STATE OF NEW HAMPSHIRE
INTER-DEPARTMENT COMMUNICATION

SUBJECT Dredge & Fill Application
Lyme Thetford, 14460

Lyme, NH – Thetford, VT, A000(394), 14460

Bridge Rehabilitation Project

STATE OF NEW HAMPSHIRE LYME AND THETFORD			
DEPARTMENT OF TRANSPORTATION • BUREAU OF HIGHWAY DESIGN			
TEMPORARY ACCESS DRIVE PLAN & PROFILE			
DGN	STATE PROJECT NO.	SHEET NO.	TOTAL SHEETS
14460ACS	14460	10	12

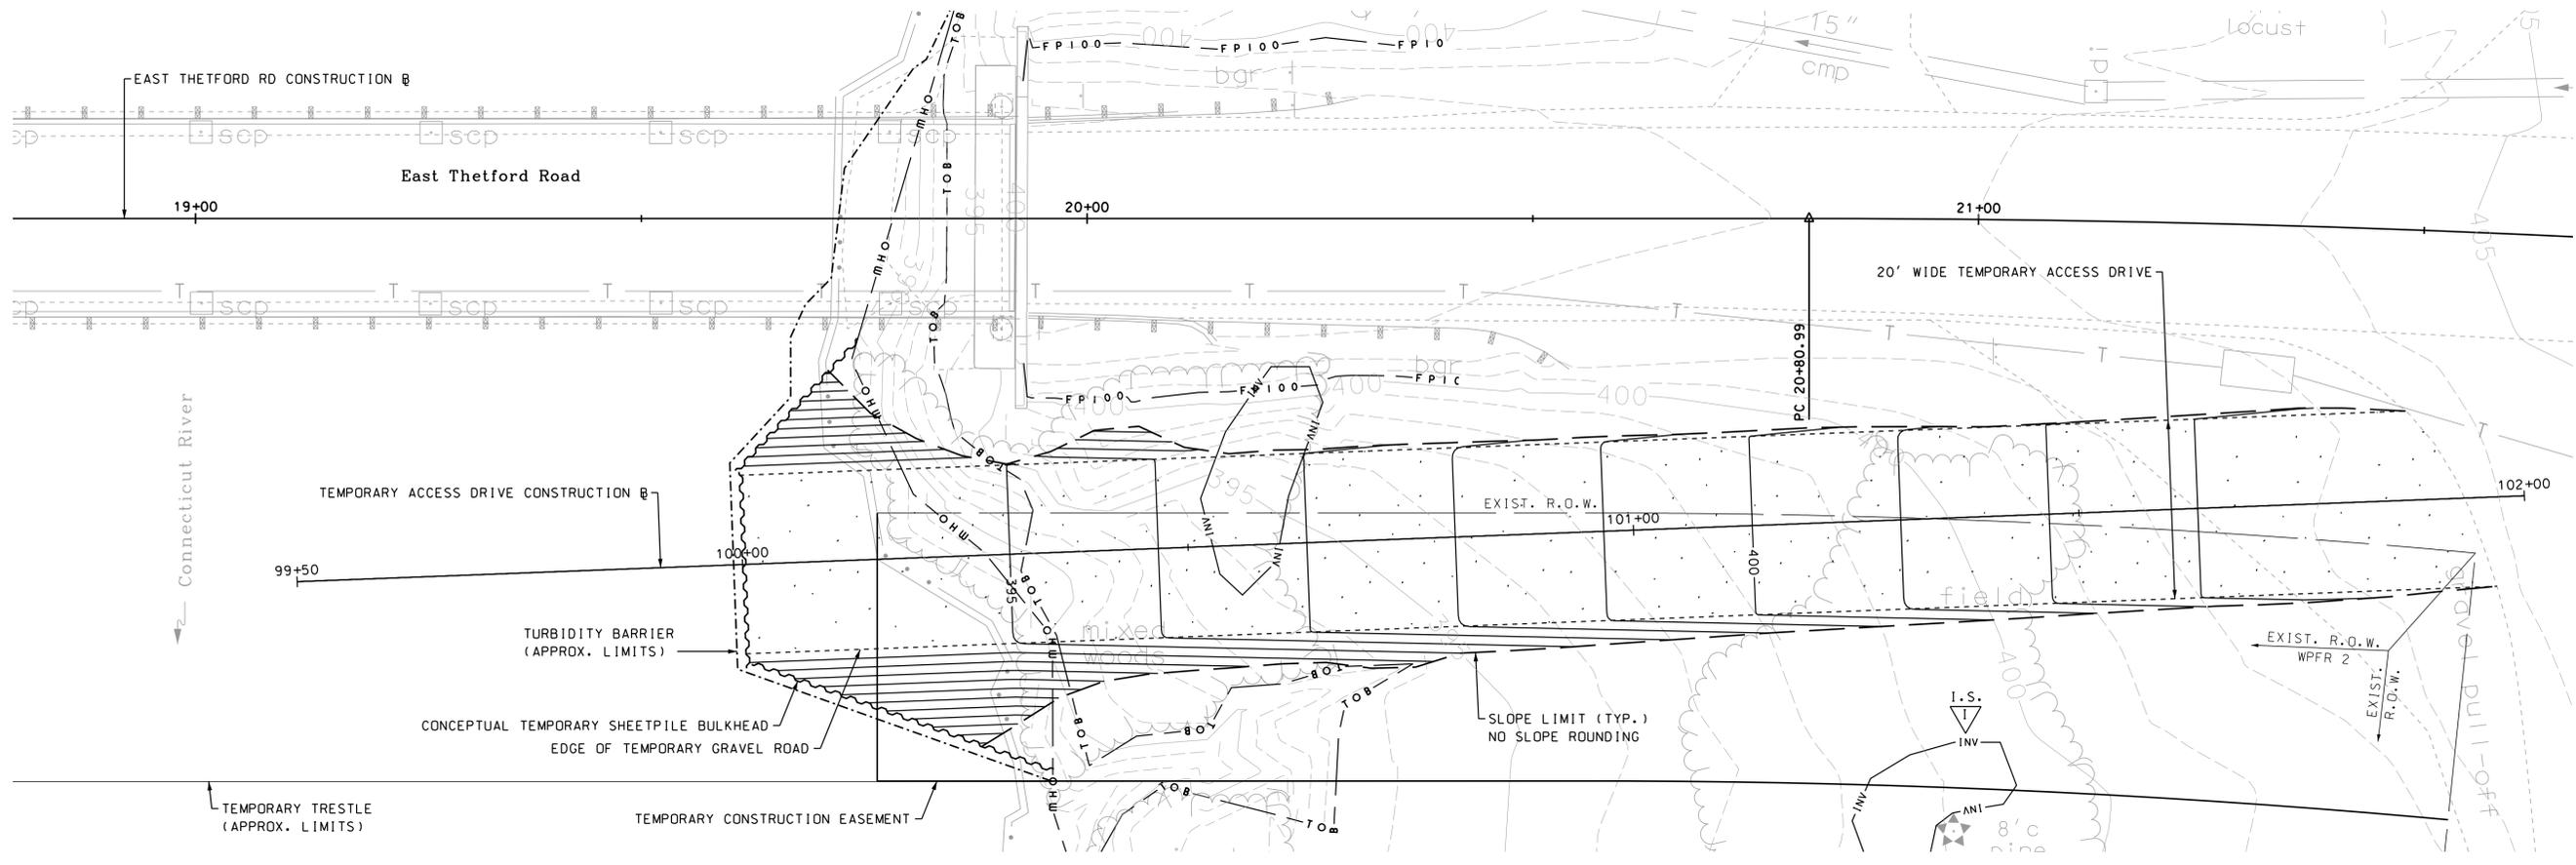
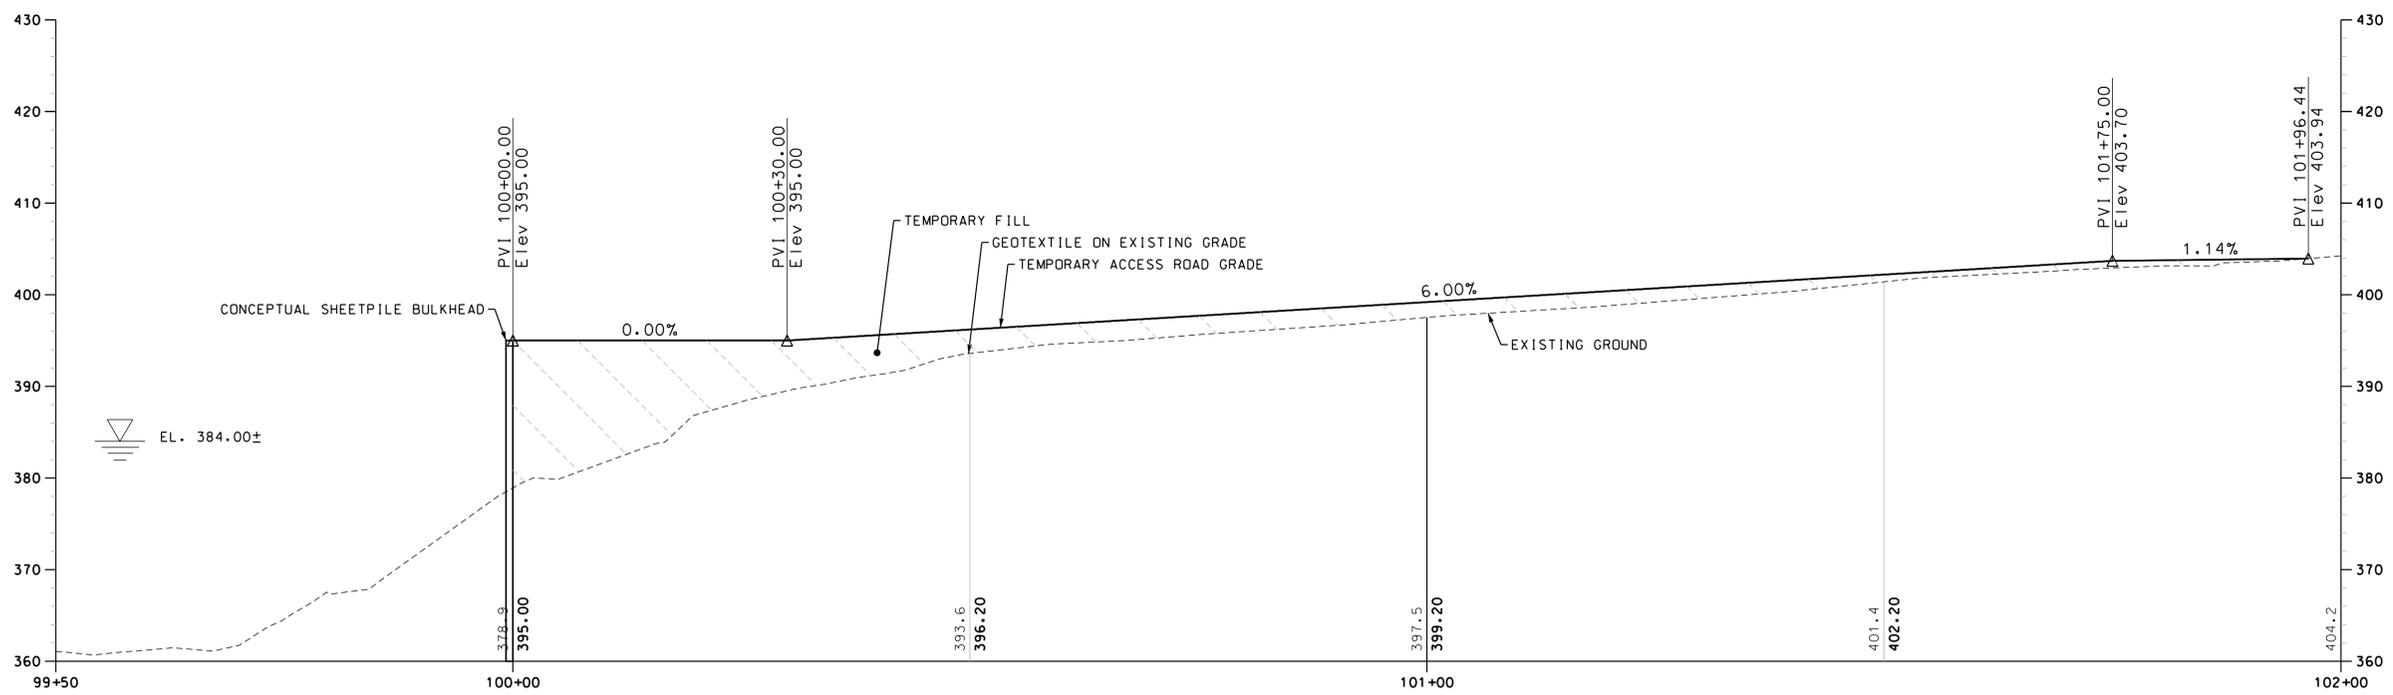
- The change to the river access from Vermont to New Hampshire at lot 22 (319 River Road) and the associated impacts under the final design. A copy of the temporary construction easement upon lot 22 for the temporary river access is provided as Exhibit V;

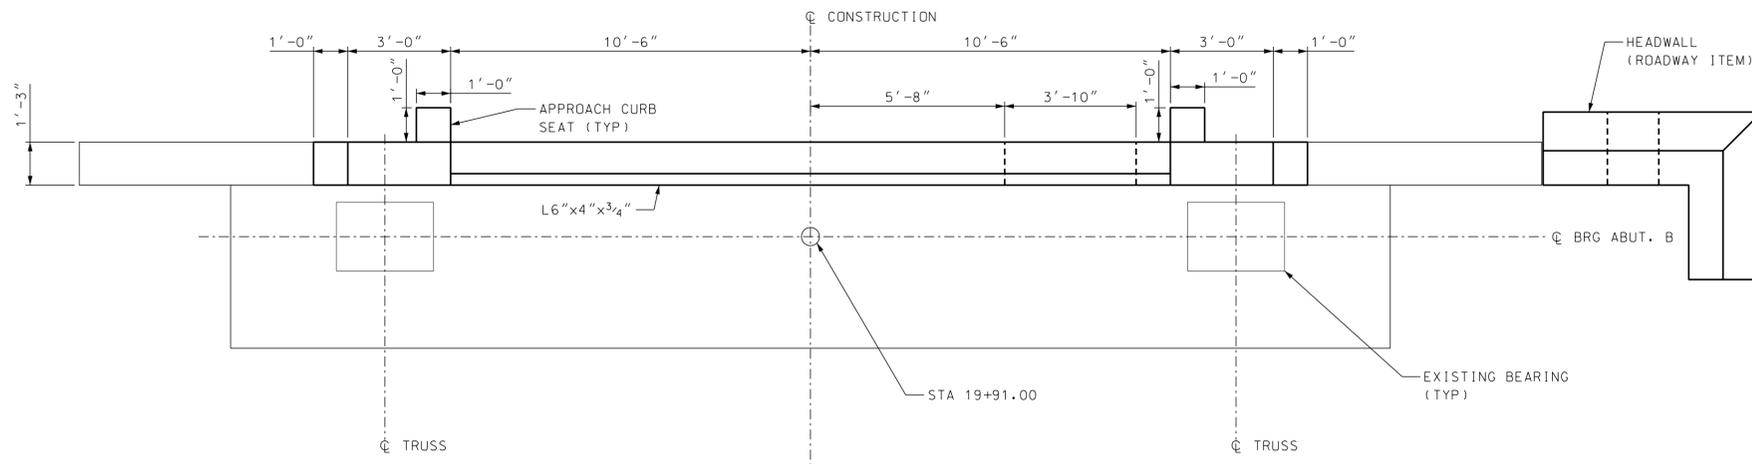
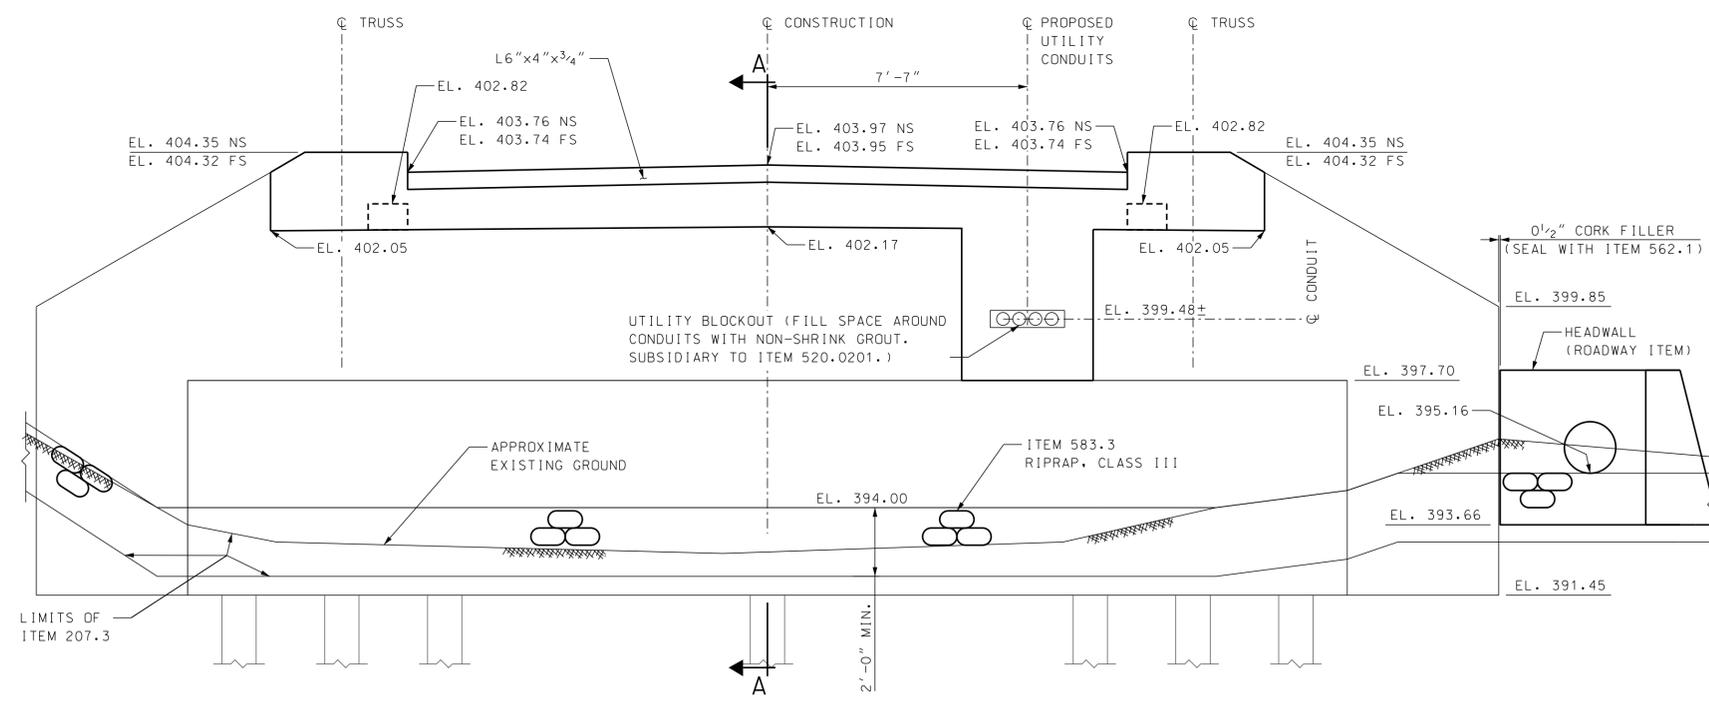
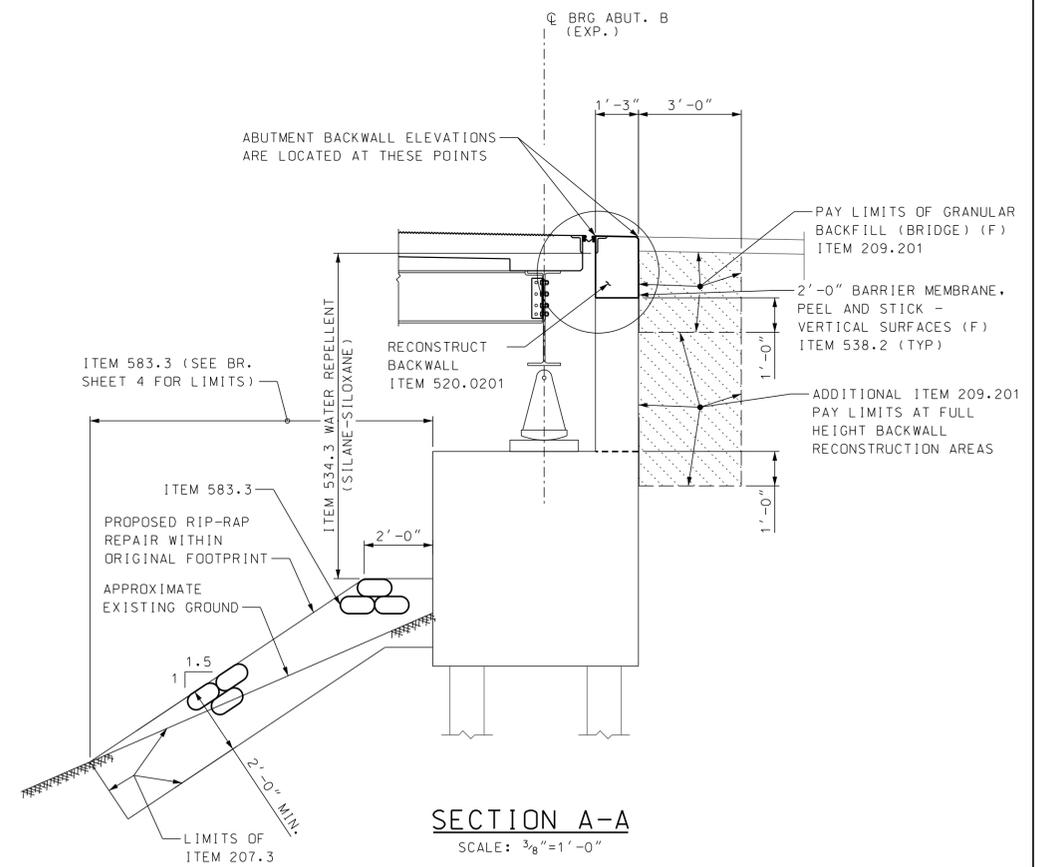
- To clarify the change to the bridge pier work from removal of the pier to rehabilitation of the existing pier under the final design. The amount of permanent impact associated with the pier work is unchanged;

The project proposes to rehabilitate the existing bridge pier in the river with one that is slightly larger and longer. The area of the rehabilitated pier will increase by 358 SF that includes an increased length of 4 feet (46 feet existing to 50 feet proposed) and increased width of 3 feet (existing 8 feet to proposed 11 feet). The bridge abutment embankment repair totaling 586 SF will be within the original riprap footprint. It is anticipated the project will not change the river current or wave energy from the original construction conditions.

DETAIL OF RIP RAP "A" + "C"

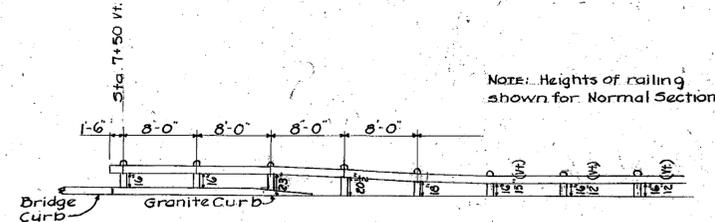
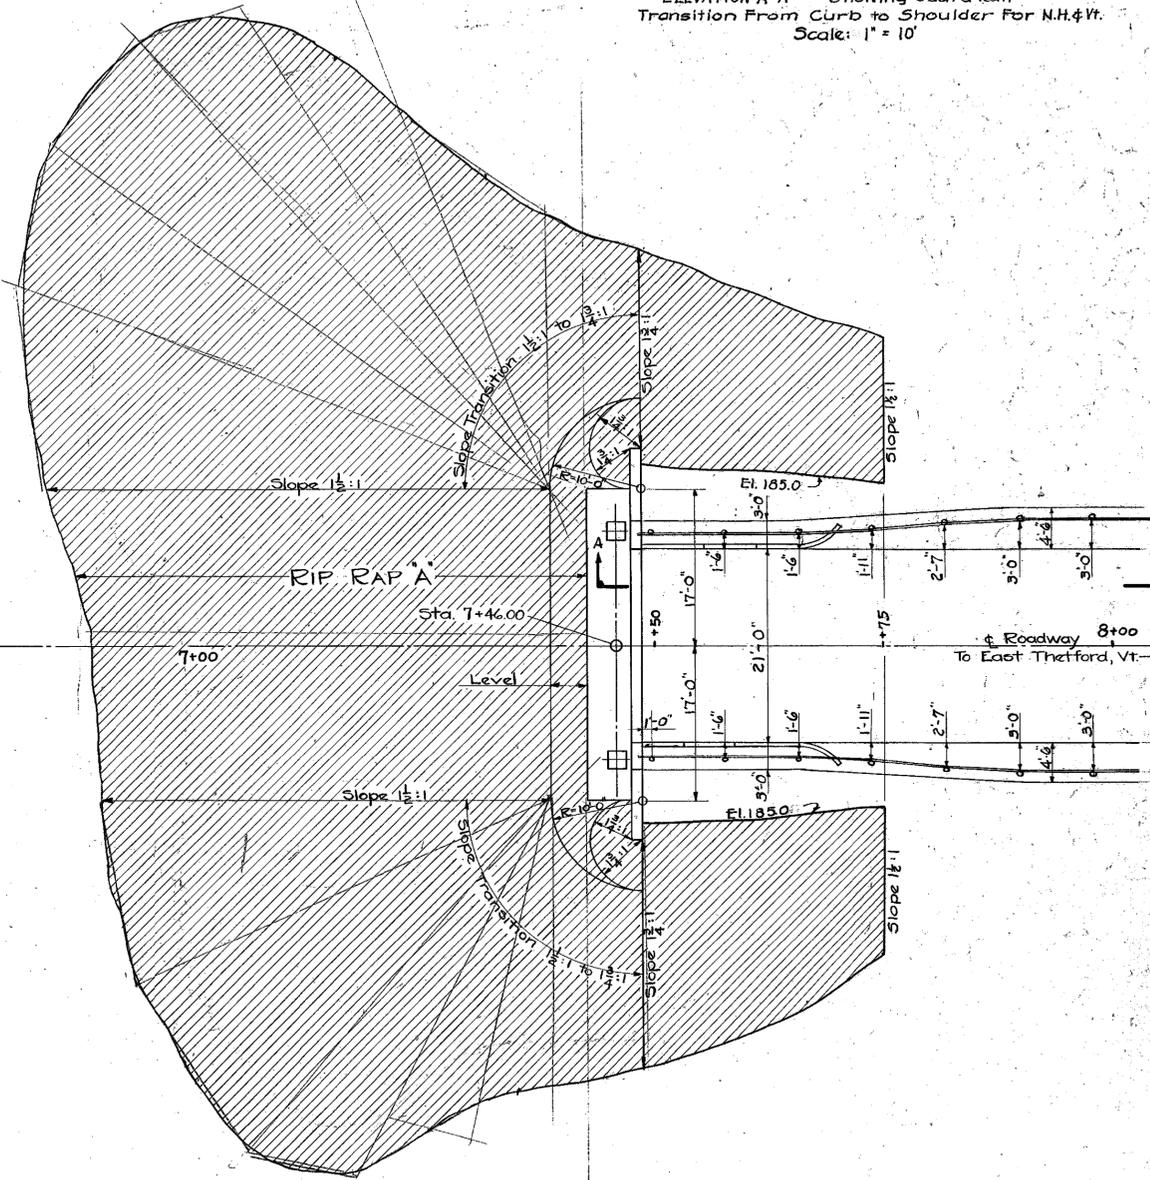
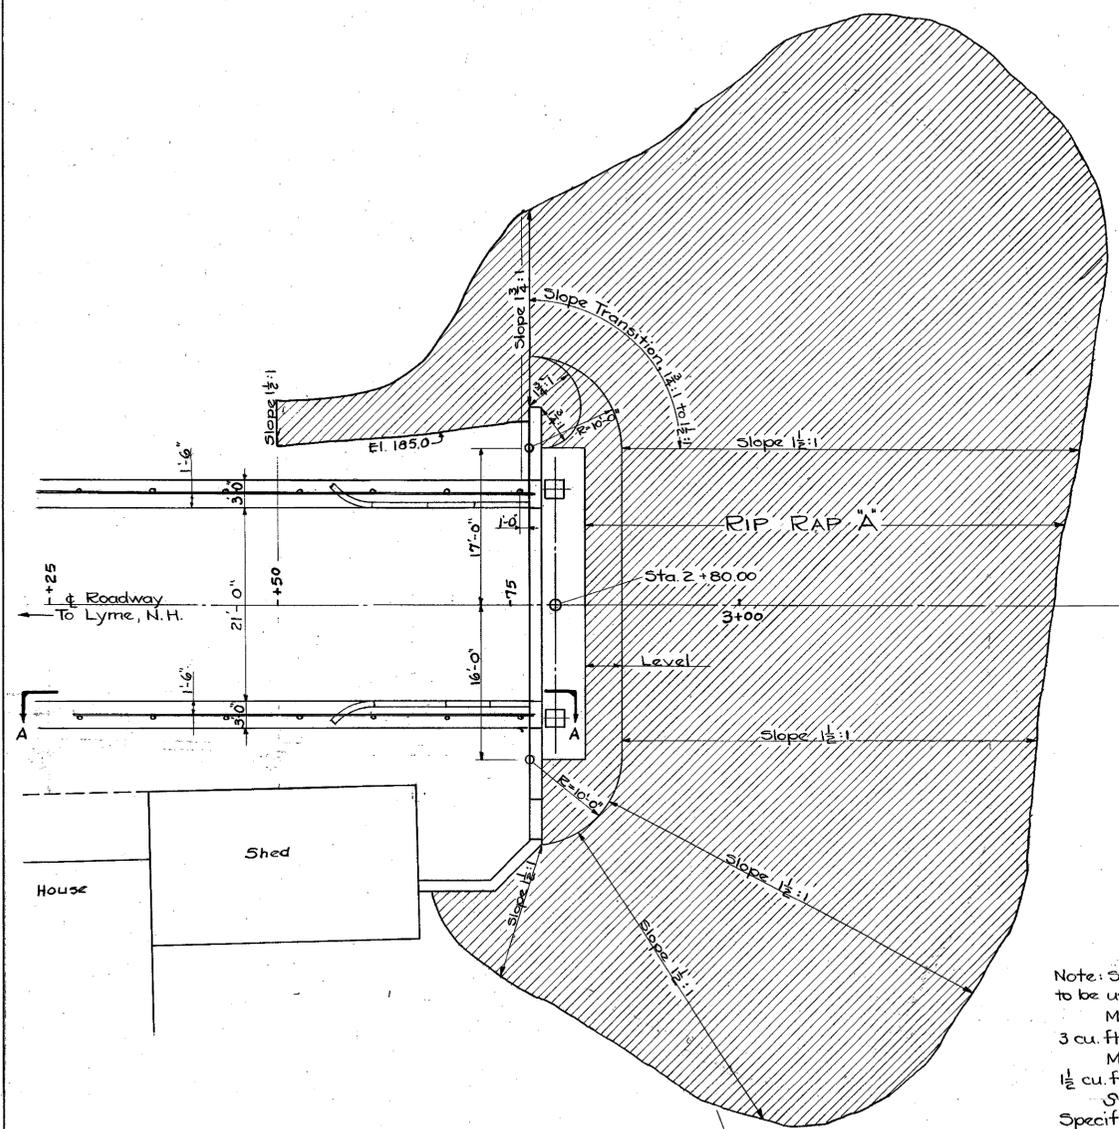
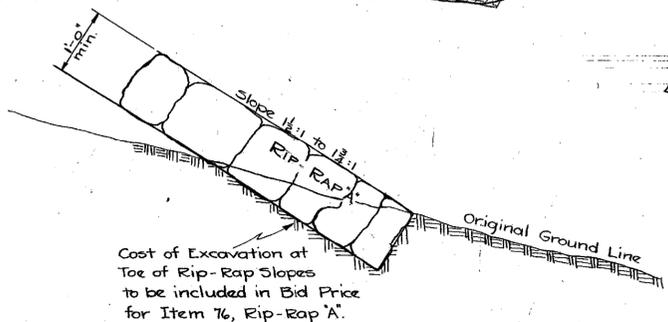
- To clarify the repair work needed to existing riprap embankment at the New Hampshire bridge abutment within the original 1937 riprap design footprint above and below the currently observed OHW line under final design;

The project includes temporary bank impacts of 324 SF and channel (below OHW) impacts of 262 SF in New Hampshire (586 SF total) to repair the existing riprap slope at the bridge abutment within the original riprap footprint of the 1937 bridge design. A copy of the original 1937 riprap design detail sheet is included in the attached amended application plan set.
